14/27-92A REVISED 23411 Ridge Road
Cedar Grove Historic District

HISTORIC PRESERVATION COMMISSION STAFF REPORT

Address: 23411 Ridge Road Meeting Date: 2/24/93
Resource: Cedar Grove Historic District Review: HAWP/Alteration
Case Number: 14/27-92A REVISED Tax Credit: No
Public Notice: 2/10/93 Report Date: 2/17/93
Applicant: Janet & Steven Wells Staff: Nancy Witherell
PROPOSAL: Build rear addition RECOMMEND: Approve

Subj: Revised Elevation Drawings for Wells Addition
Cedar Grove Historic District

EAST ELEVATION

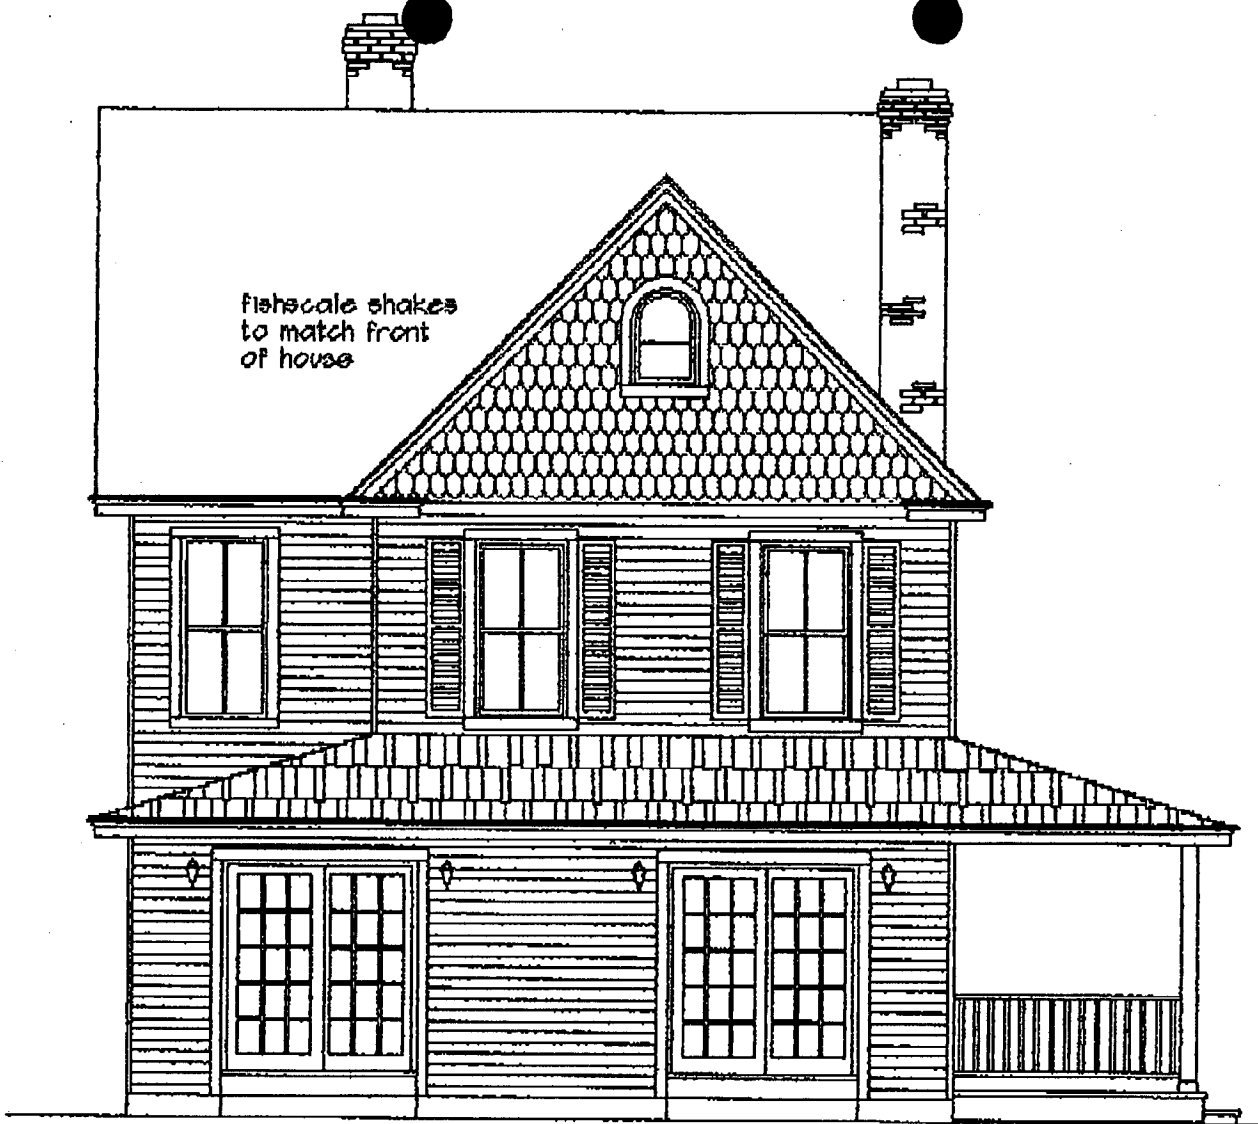
1. The enclosed elevation drawings incorporate the changes discussed with you on the phone. We have added a wrap-around porch on the north side and removed the double windows on the first and second floors. We think that this fits in better with the existing house. We also replaced one set of double windows on the east side with matching "French" doors. The chimney has been enclosed in the wall on the north side also.

NORTH ELEVATION

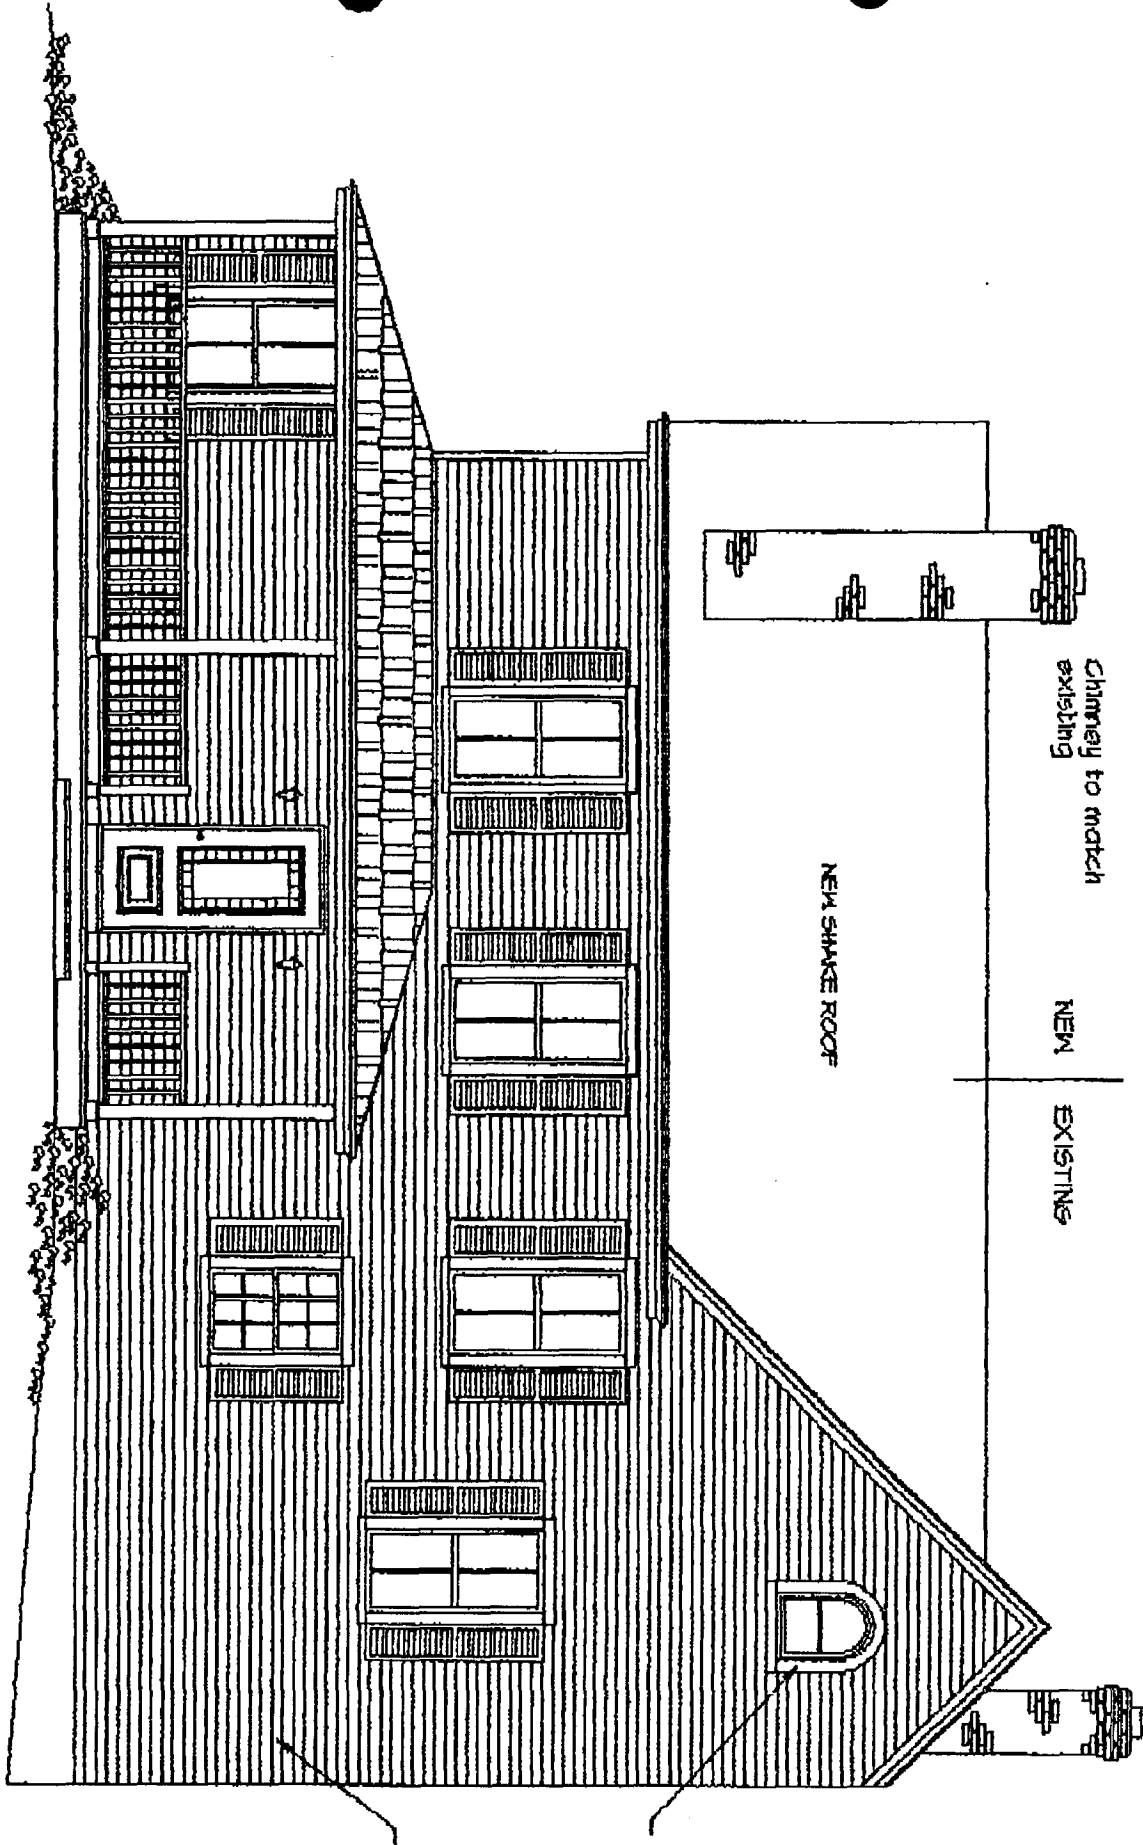
The revision proposes continuing the hip around the north elevation of the new addition. This has the benefit, in the staff's judgment, of continuing the roof form in a more natural way, and of integrating the new door on the north elevation with the wrap-around rear porch. No articulation of the door surround is necessary. The result would be a door that would appear to be secondary to the front door.

NORTH ELEVATION

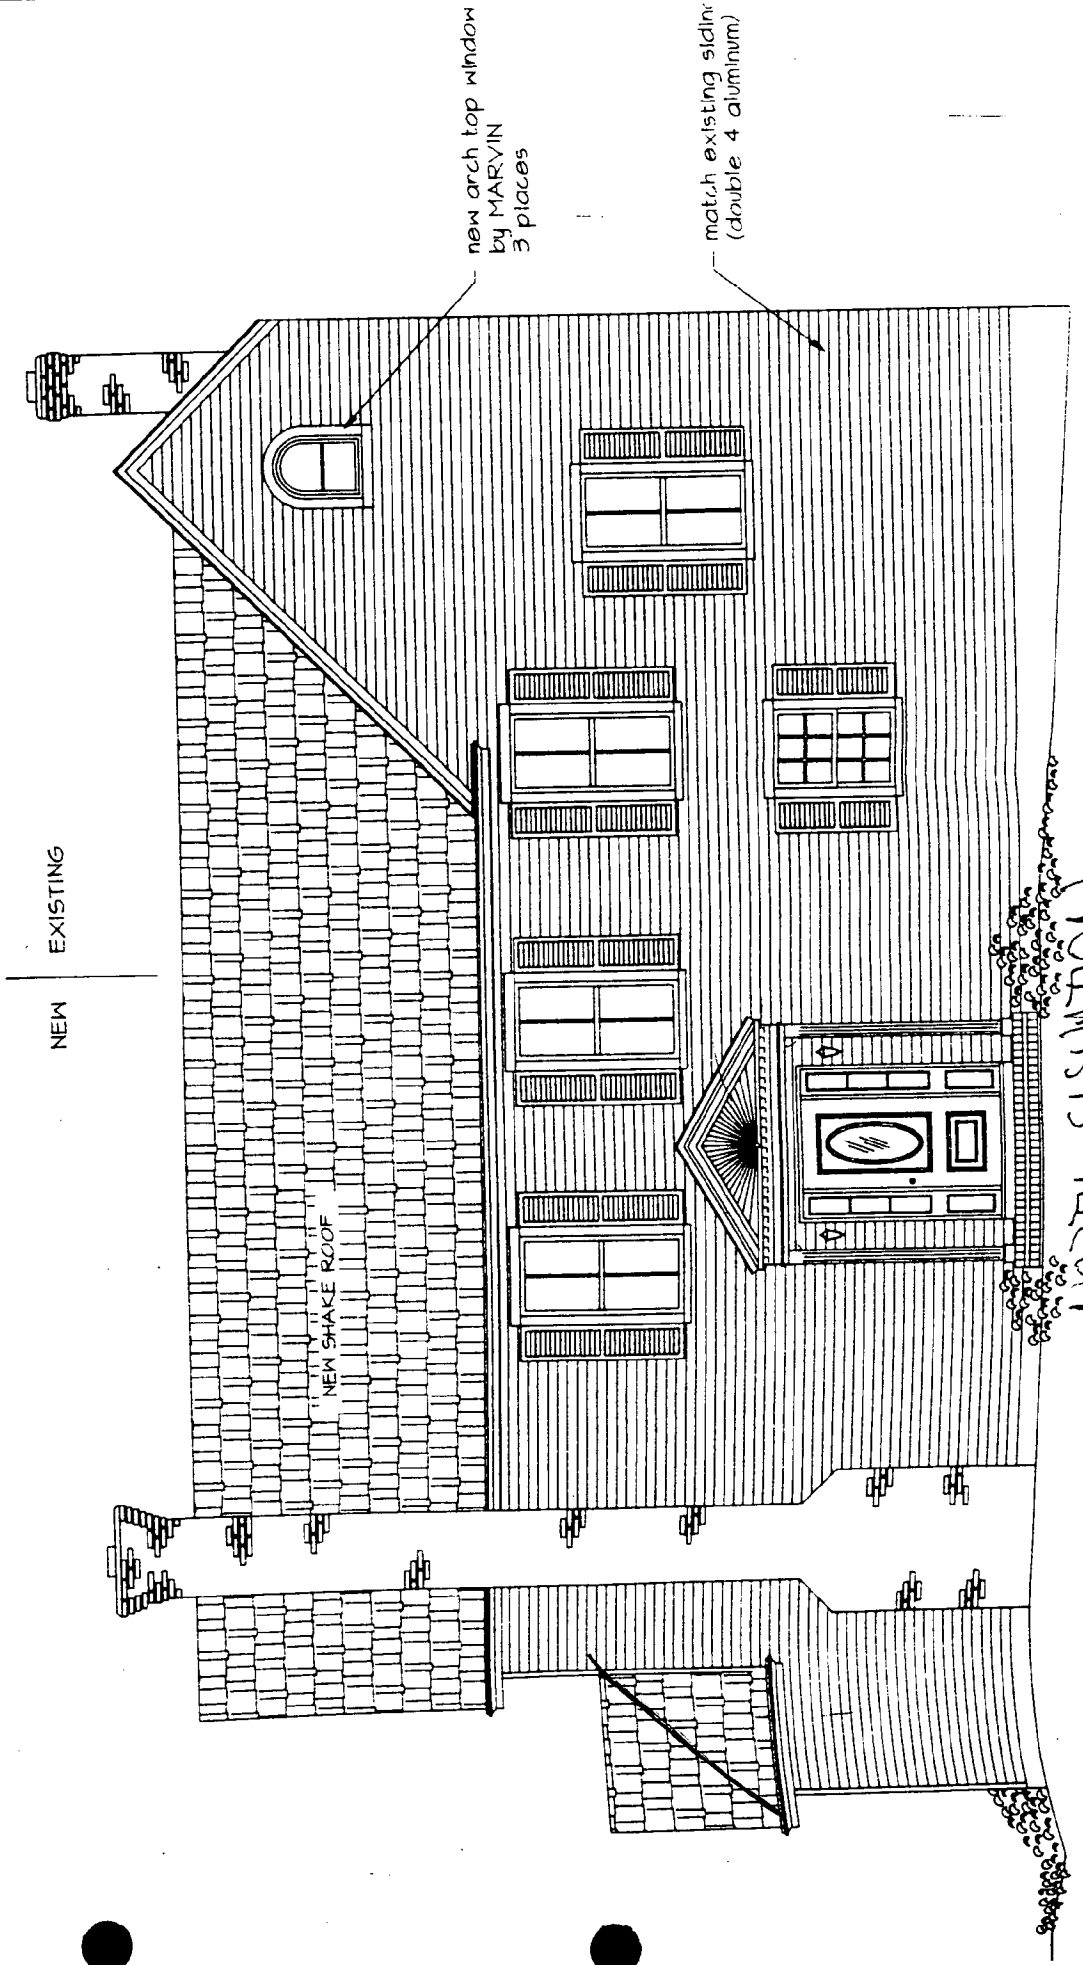
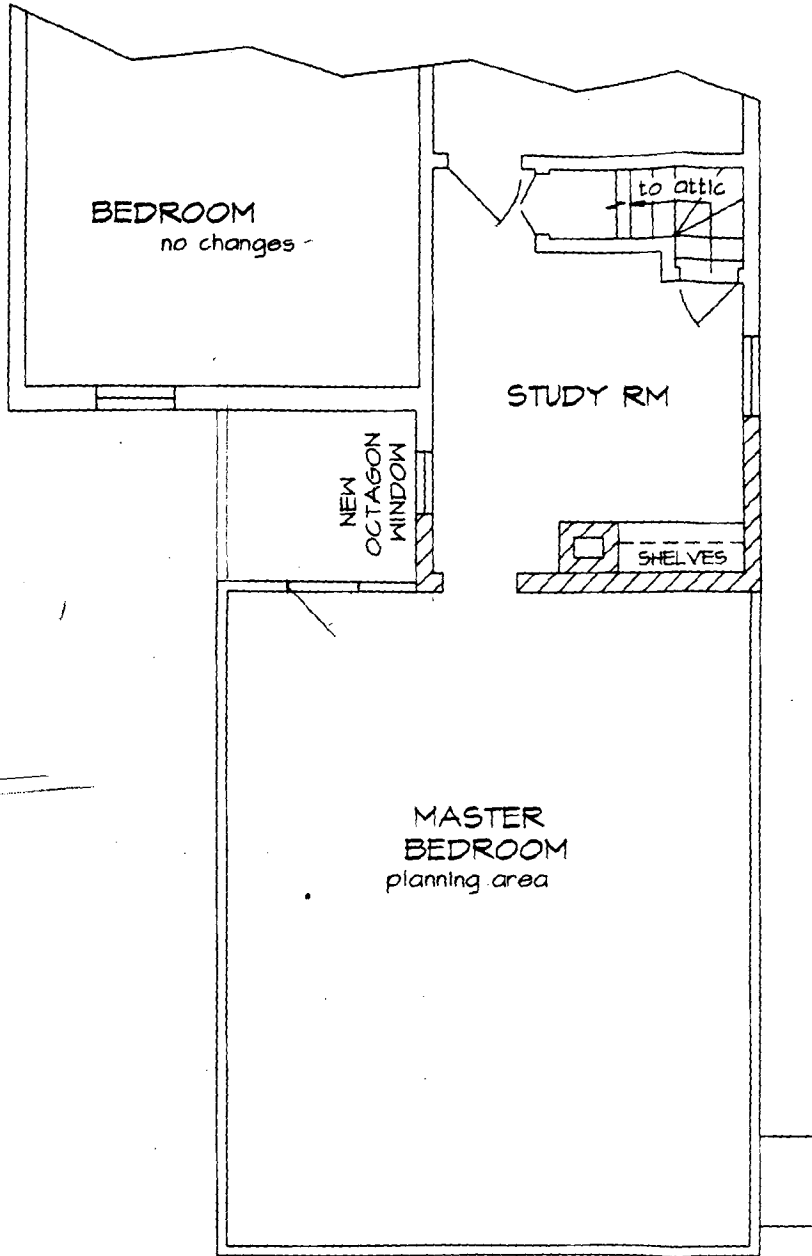
The applicant agrees with the staff that the design of the new side door and small portico is out-of-character for a house of this style. The proposal would be simplified by the elimination of the fluting from the porch posts, of the sidelights, of the sunburst in the pediment, and of the oval glass in the door. Instead, it would have plain porch posts similar to those on the front porch, fishscale shingles in the pediment, and a Queen Anne sash window in the door.
